Service Bulletin for AVT 100/150/275 Static Problem/Dead OD Channel

STATIC MOD

DWG. No.	SK000126
ISSUE	A

AVT150, AVT150H, AVT275

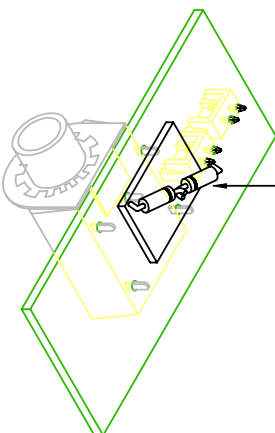
FIT DIODES AS SHOWN
AFFIX INSULATING PAD
UNDER DIODES.

AVT100

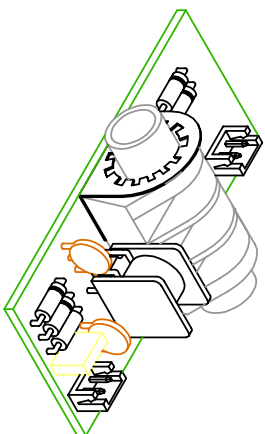
FIT DIODES AS SHOWN
AFFIX INSULATING PAD
UNDER DIODES.
